PADDOCK PLACE SUBDIVISION

APPLICATION NUMBER 19 DATE June 5, 2003

REQUEST Subdivision

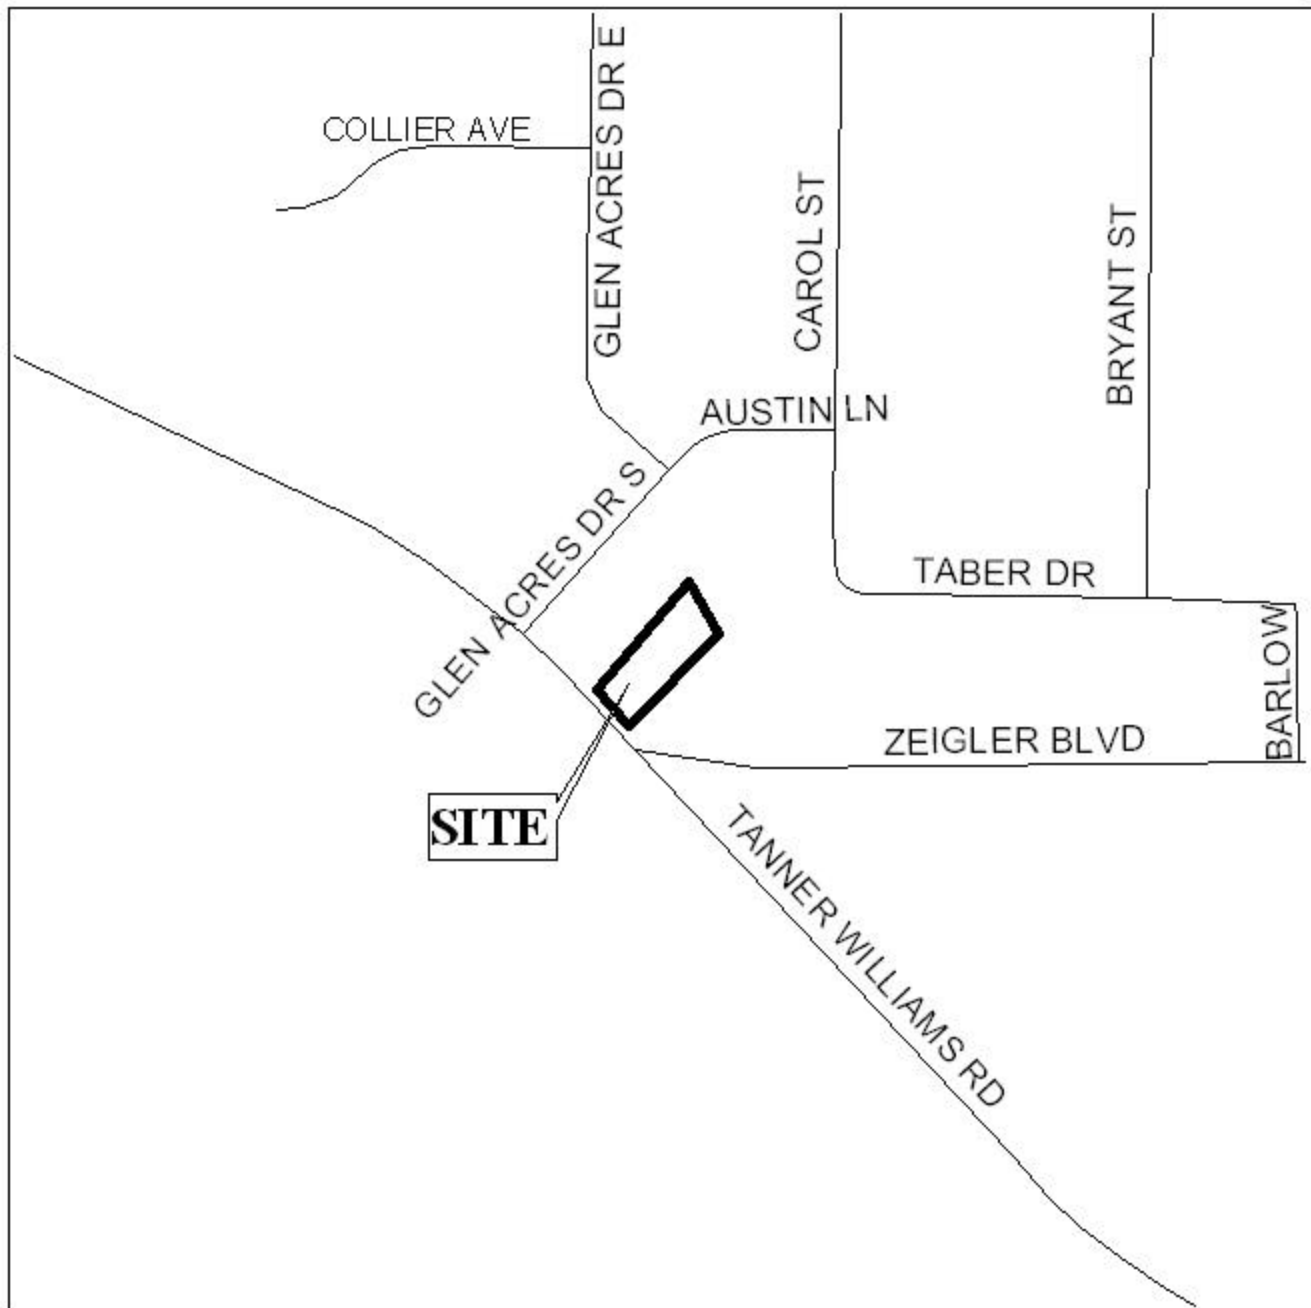
The site fronts Tanner Williams Road, a planned major street, which has an existing right-of-way of 80-feet. However, the Major Street Plan requires a 100-foot right-of-way; therefore, the dedication of sufficient right-of-way to provide 50-feet from the centerline of Tanner Williams Road, should be required. Additionally, as a means of access management, a note should be placed on the final plat limiting the development to share one curb cut, with the size, location and design to be approved by County Engineering.

Lot 2 exceeds the maximum width to depth ratio as recommended by the Subdivision Regulations; therefore, a waiver of Section V.D.3. would be required.

As illustrated on the Vicinity Map two buildings are constructed across the proposed property line, thus the portion of the buildings which crosses the property line should be removed prior to the recording of the final plat.

With modifications and a waiver of Section V.D.3., the plat will meet the minimum requirements of the Subdivision Regulations and is recommended for Tentative Approval subject to the following conditions: 1) the dedication of the necessary right-of-way to provide 50-feet from the centerline of Tanner Williams Road; 2) the placement of a note on the final plat stating that the development is limited to one shared one curb to Tanner Williams Road, with the size, location and design to be approved by County Engineering; 3) the removal all buildings crossing any property lines prior to the recording of the final plat; and 4) the placement of a note on the final plat stating that a buffer, in compliance with Section V.A.7. will be provided where the site adjoins residentially developed property.
